MONTGOMERY COUNTY HISTORIC PRESERVATION COMMISSION
STAFF REPORT

Address:	11 East Lenox Street, Chevy Chase	Meeting Date:	4/25/2018
Resource:	Contributing Resource Chevy Chase Village Historic District	Report Date:	4/18/2018
Applicant:	Brit and Kelleen Snider (Luke Olson, Architect)	Public Notice:	4/11/2018
Review:	HAWP	Tax Credit:	N/A
Case Number:	35/13-18D 2 nd REVISION		
PROPOSAL:	Building addition

FIRST FLOOR
PLAN

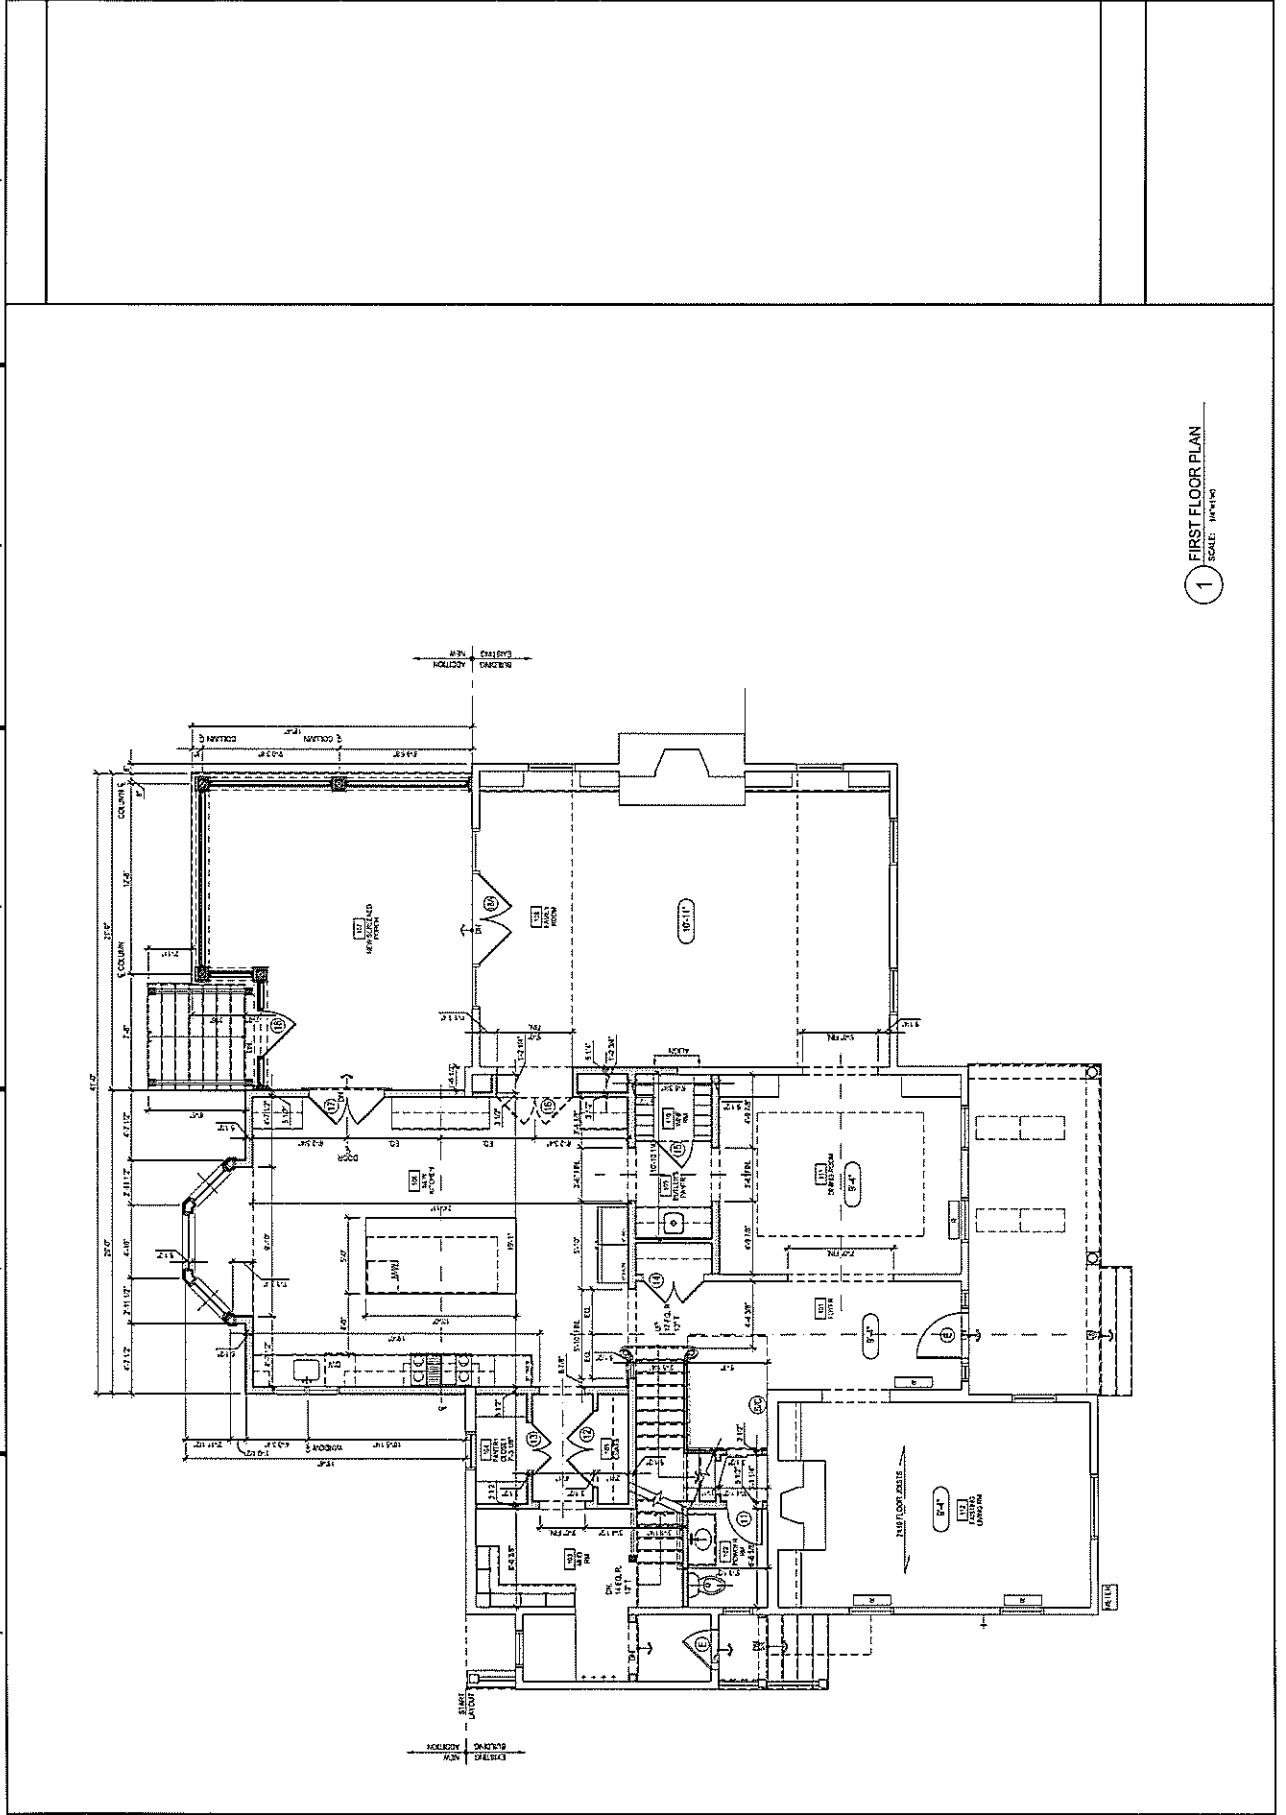
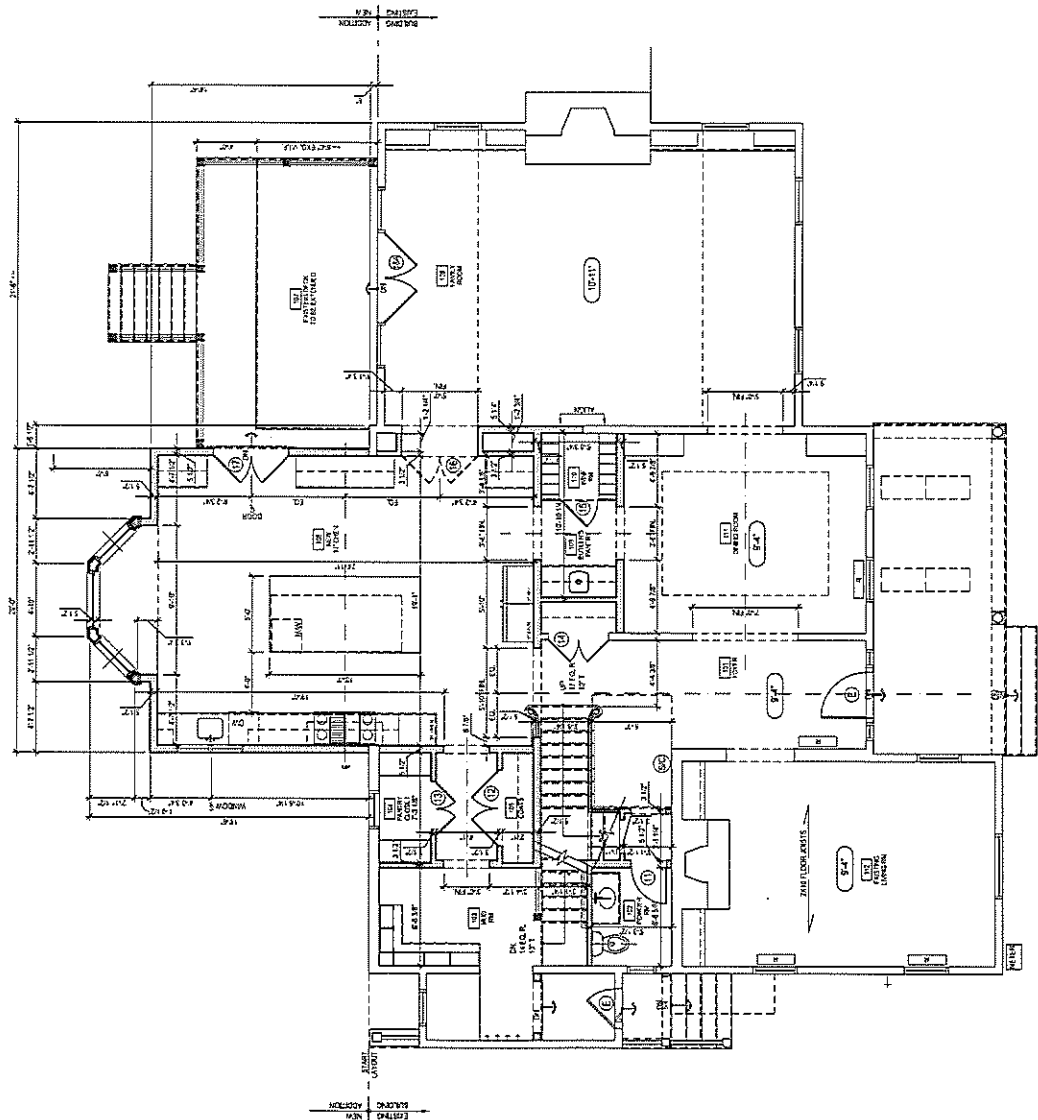
- Replace/extend the existing wooden deck in lieu of constructing the previously approved screened porch in its place. *The existing wooden deck is non-historic and is located behind an existing non-historic right-side addition. The applicant proposes to remove the existing deck and construct a new paintable composite deck in its place. The proposed new deck will extend 4' further into the rear yard than the existing deck. The proposed new deck will have paintable composite railings, with square balusters spaced 4" on center. The railings will be traditional, with the balusters inset between the top and bottom rails. The proposed alterations will only be minimally visible from oblique angles in the public right-of-way. Staff finds that the proposed revisions will not detract from the character-defining features of the subject property or surrounding streetscape.*

Staff recommends that the Commission **approve** the HAWP application under the Criteria for Issuance in Chapter 24A-8(b), having found that the proposal is consistent with the *Chevy Chase Village Historic District Guidelines* identified above, and therefore will not substantially alter the exterior features of the historic resource and is compatible in character with the district and the purposes of Chapter 24A;
